Access Audit Site Report

Devils River State Natural Area - Del Norte Unit

Accessibility Evaluation

Inspection Date: 10/17/2022

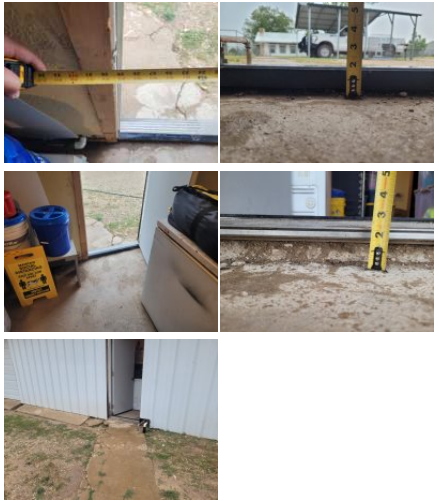
Finding Number	Area Description	Lat/Long	Finding	As Built	Recommendation	Citation	Photos	Figure
19	Headquarters Area: HQ - Employee Spaces	[29.94107, -100.9712]	The threshold has a vertical change greater than 1/4 inch high. The threshold at a doorway shall be no higher than 1/2 inch. Changes in level between 1/4 inch and 1/2 inch must be beveled at 1:2 or less. 1/4 inch is the maximum vertical rise. Doors, gates, and side lights adjacent to doors or gates, containing one or more glazing panels that permit viewing through the panels shall have the bottom of at least one glazed panel located 43 inches (1090 mm) maximum above the finish floor. EXCEPTION: Vision lights with the lowest part more than 66 inches (1675 mm) from the finish floor or ground shall not be required to comply with 404.2.11.	kitchen exit- CIL, 1" threshold, 47" window	For all doors along the public circulation route, repair, bevel, or ramp CILs at door entries to max .25". For all doors along the public circulation route, provide beveled threshold. For all doors along the public circulation route, replace doors with ones having sidelight viewing windows max 43" AFF.	2010 ADAS Section: 404.2.3, 404.2.7, 404.2.4, 404.2.11, 404.2.11 Exception

20	Headquarters Area: HQ - Employee Spaces	[29.9410808, -100.9712858]	Minimum maneuvering clearances at doors and gates shall comply with 404.2.4. Maneuvering clearances shall extend the full width of the doorway and the required latch side or hinge side clearance. Maneuvering clearances shall have a max slope of 2.08%. The threshold has a vertical change greater than 1/4 inch high. The threshold at a doorway shall be no higher than 1/2 inch. Changes in level between 1/4 inch and 1/2 inch must be beveled at 1:2 or less. 1/4 inch is the maximum vertical rise. Doors, gates, and side lights adjacent to doors or gates, containing one or more glazing panels that permit viewing through the panels shall have the bottom of at least one glazed panel located 43 inches (1090 mm) maximum above the finish floor. EXCEPTION: Vision lights with the lowest part more than 66 inches (1675 mm) from the finish floor or ground shall not be required to comply with 404.2.11.	laundry exit- CIL, gravel, window 47", storage pull side	For all doors along the public circulation route, provide required maneuvering clearance on push and pull side of doors. For all doors along the public circulation route, repair, bevel, or ramp CILs at door entries to max .25". For all doors along the public circulation route, provide beveled threshold. For all doors along the public circulation route, replace doors with ones having sidelight viewing windows max 43" AFF.	2010 ADAS Section: 404.2.3, 404.2.7, 404.2.4, 404.2.11, 404.2.11 Exception

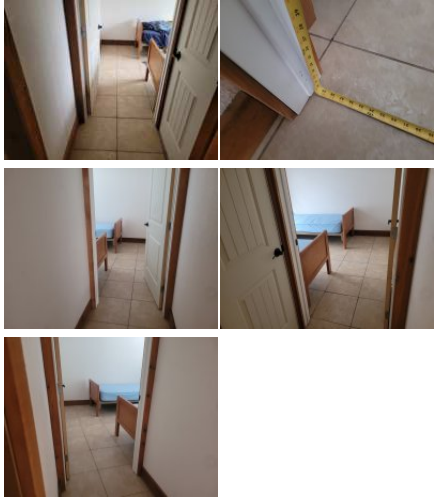
Finding Number	Area Description	Lat/Long	Finding	As Built	Recommendation	Citation	Photos	Figure
38	Park Site: Bunkhouse	[29.9408532 , -100.9704 176]	The grab bar height and/or spacing fails. Grab bars must be mounted between 33" and 36" to the top of the gripping surface. There must be 1.5" of clearance between the grab bar and the wall. There must be a minimum of 1.5" of clearance below and minimum 12" above the grab bar to any dispenser or other obstruction.	bunkhouse exterior restroom- disposal can 1" below bar	Remount disposal can, 15" to 48" above the finished floor (AFF) and min 12" above or 1.5" below grab bar.	2015 ABAAS Section: 609.3, 609.4 2012 TAS Section: 609.4, 609.3 2010 ADAS Section: 609.3, 609.4		
39	Park Site: Bunkhouse	[29.9408369 , -100.9704 176]	The flush handle is located on the wrong side of the toilet. Controls shall be operable with one hand and shall not require tight grasping, pinching or twisting. Controls for the flush valves shall be mounted on the wide side of toilet areas, no more than 44 inches above the floor.	bunkhouse exterior restroom- flush on wall side	Replace toilet tank with one having flush mechanism on the open side, in the alternative, install an auto flush unit.	2015 ABAAS Section: 604.6 2012 TAS Section: 604.6 2010 ADAS Section: 604.6

40	Park Site: Bunkhouse	[29.9408578 , -100.9704 122]	The toilet paper is not installed within the compliant range in front of the toilet. Toilet paper dispensers shall be 7 inches minimum and 9 inches maximum in front of the water closet measured to the centerline of the dispenser. The outlet of the dispenser shall be 15 inches minimum and 48 inches maximum above the finish floor and shall not be located behind grab bars. Dispensers shall not be of a type that controls delivery or that does not allow continuous paper flow. There shall be a clearance of 1 1/2 inches minimum below the grab bar.	bunkhouse exterior restroom- tp too close	Remount toilet paper dispenser 7" to 9" from front of toilet, 15" to 48" AFF and min 12" above or 1.5" below grab bar.	2015 ABAAS Section: 604.7 2012 TAS Section: 604.7 2010 ADAS Section: 604.7

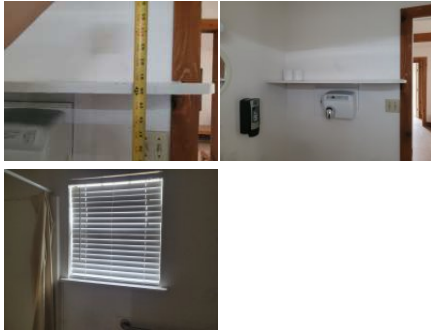
Finding Number	Area Description	Lat/Long	Finding	As Built	Recommendation	Citation	Photos	Figure
49	Park Site: Bunkhouse	[29.9408665 , -100.9704 199]	Minimum maneuvering clearances at doors and gates shall comply with 404.2.4. Maneuvering clearances shall extend the full width of the doorway and the required latch side or hinge side clearance. Maneuvering clearances shall have a max slope of 2.08%. Door openings shall provide a clear width of 32 inches (815 mm) minimum. Clear openings of doorways with swinging doors shall be measured between the face of the door and the stop, with the door open 90 degrees. Openings more than 24 inches (610 mm) deep shall provide a clear opening of 36 inches (915 mm) minimum. There shall be no projections into the required clear opening width lower than 34 inches (865 mm) above the finish floor or ground. Projections into the clear opening width between 34 inches (865 mm) and 80 inches (2030 mm) above the finish floor or ground shall not exceed 4 inches (100 mm). The threshold has a vertical change greater than 1/4 inch high. The threshold at a doorway shall be no higher than 1/2 inch. Changes in level between 1/4 inch and 1/2 inch must be beveled at 1:2 or less. 1/4 inch is the maximum vertical rise. Egress doors shall provide a continuous and unobstructed way of egress travel from any point in a building or facility that provides an accessible route to an area of refuge, a horizontal exit, or a public way.	rear exit- lacks AR/egress, steps and CIL exterior, bed back pull side, 29" wide, 1" threshold	For all doors along the public circulation route, provide required maneuvering clearance on push and pull side of doors. For all doors along the public circulation route, replace doors with doors having 80" overhead clearance and 32" clear width. For all doors along the public circulation route, repair, bevel, or ramp CILs at door entries to max .25". For all doors along the public circulation route, provide beveled threshold. For all doors along the public circulation route, enlarge cement pad at exit to allow 18" clearance on the latch side, and extend a pathway away from the building for emergency egress.	2010 ADAS Section: 404.2.3, 404.2.7, 404.2.4, 404.2.11, 404.2.11 Exception

50	Park Site: Bunkhouse	[29.9408693 , -100.9704 184]	Element meets all standards and requirements	all 5 bedrooms have space between beds	None	2010 ADAS Section: N/A

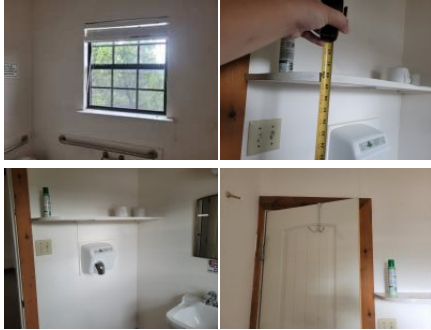
Finding Number	Area Description	Lat/Long	Finding	As Built	Recommendation	Citation	Photos	Figure
59	Park Site: Bunkhouse	[29.9408777 , -100.9704 107]	The toilet is not located within the range allowed from the side wall or partition. The centerline of the toilet must be 16 to 18 inches from the side wall.	left- centerline 15"	Remount toilets to 16" to 18" from the side wall to centerline	2015 ABAAS Section: 604.2 2012 TAS Section: 604.2 2010 ADAS Section: 604.2		
60	Park Site: Bunkhouse	[29.9408684 , -100.9704 215]	The toilet seat is not located within the range allowed off the floor. The height of accessible water closets shall be a minimum of 17 inches and a maximum of 19 inches measured to the top of a maximum 2-inch high toilet seat.	left- seat height 16"	Replace toilet seat, or re-set or replace toilet to 17" to 19" above the finished floor (AFF).	2015 ABAAS Section: 604.4 2012 TAS Section: 604.4 2010 ADAS Section: 604.4

61	Park Site: Bunkhouse	[29.9408708 , -100.9704 188]	The side grab bars are not in the correct location. Grab bars on the side wall must be installed so that the end closest to the rear wall is maximum 12" from the rear wall. The end furthest from the rear wall must be mounted minimum 54" from the rear wall.	left- 36" side bar	Replace side grab bar with a 42" long bar mounted to max 12" from the rear wall at the close end and min 54" on the far end, and 33" to 36" aff.	2015 ABAAS Section: 604.5.1 2012 TAS Section: 604.5.1 2010 ADAS Section: 604.5.1

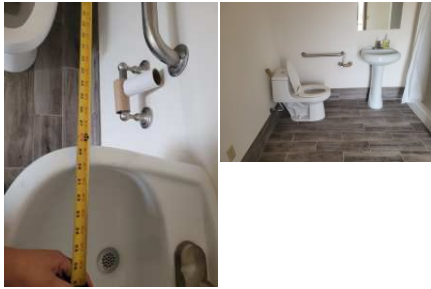
Finding Number	Area Description	Lat/Long	Finding	As Built	Recommendation	Citation	Photos	Figure
92	Park Site: Composting Toilet	[29.8945837 , -100.9947 464]	The rear grab bar is not 36" long or is not mounted in the correct location. The rear grab bar must be a minimum of 36" long and extend from the toilet centerline a minimum 12" towards the wall side and a minimum 24" towards the open side of the toilet. Grab bars shall be installed in a horizontal position, 33 inches minimum and 36 inches maximum above the finish floor measured to the top of the gripping surface and the space between the grab bar and the top of the tank shall be 1-1/2 inches minimum.	rear bar 20" to open side	Remount rear grab bar to behind the toilet, 12" to the wall side of center and 24" to the open side and 33" to 36" AFF.	2015 ABAAS Section: 604.5.2 2012 TAS Section: 604.5.2 2010 ADAS Section: 604.5.2		
93	Park Site: Composting Toilet	[29.8945814 , -100.9947 464]	The grab bar height and/or spacing fails. Grab bars must be mounted between 33" and 36" to the top of the gripping surface. There must be 1.5" of clearance between the grab bar and the wall. There must be a minimum of 1.5" of clearance below and minimum 12" above the grab bar to any dispenser or other obstruction.	grab bars 37" aff	Remount grab bars in accessible stall to 33" to 36" above the finished floor (AFF).	2015 ABAAS Section: 609.3, 609.4 2012 TAS Section: 609.4, 609.3 2010 ADAS Section: 609.3, 609.4

94	Park Site: Composting Toilet	[29.8945791 , -100.99474 9]	The toilet paper is not installed within the compliant range in front of the toilet. Toilet paper dispensers shall be 7 inches minimum and 9 inches maximum in front of the water closet measured to the centerline of the dispenser. The outlet of the dispenser shall be 15 inches minimum and 48 inches maximum above the finish floor and shall not be located behind grab bars. Dispensers shall not be of a type that controls delivery or that does not allow continuous paper flow. There shall be a clearance of 1 1/2 inches minimum below the grab bar.	tp too far	Remount toilet paper dispenser 7" to 9" from front of toilet, 15" to 48" AFF and min 12" above or 1.5" below grab bar.	2015 ABAAS Section: 604.7 2012 TAS Section: 604.7 2010 ADAS Section: 604.7

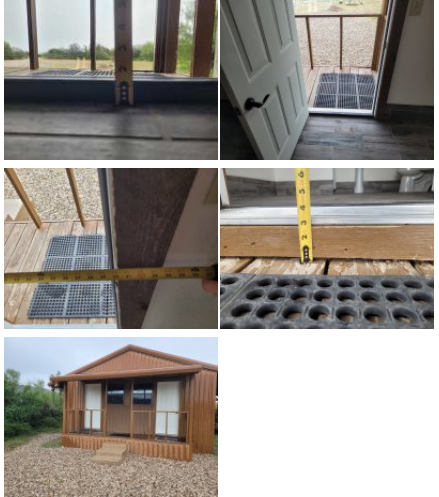
Finding Number	Area Description	Lat/Long	Finding	As Built	Recommendation	Citation	Photos	Figure
103	Park Site: Restroom/Shower Building	[29.9396588 , -100.9702 878]	The side grab bars are not in the correct location. Grab bars on the side wall must be installed so that the end closest to the rear wall is maximum 12" from the rear wall. The end furthest from the rear wall must be mounted minimum 54" from the rear wall.	both- 24" side bar, bar 2.5" from wall	Replace side grab bar with a 42" long bar mounted to max 12" from the rear wall at the close end and min 54" on the far end, with 1.5" gap to wall, and 33" to 36" aff.	2015 ABAAS Section: 604.5.1 2012 TAS Section: 604.5.1 2010 ADAS Section: 604.5.1		
104	Park Site: Restroom/Shower Building	[29.9396681 , -100.9702 878]	The rear grab bar is not 36" long or is not mounted in the correct location. The rear grab bar must be a minimum of 36" long and extend from the toilet centerline a minimum 12" towards the wall side and a minimum 24" towards the open side of the toilet. Grab bars shall be installed in a horizontal position, 33 inches minimum and 36 inches maximum above the finish floor measured to the top of the gripping surface and the space between the grab bar and the top of the tank shall be 1-1/2 inches minimum.	both- lack rear bar	Replace rear grab bar with one 36" long, mounted behind the toilet, 12" to the wall side of center and 24" to the open side and 33" to 36" AFF.	2015 ABAAS Section: 604.5.2 2012 TAS Section: 604.5.2 2010 ADAS Section: 604.5.2
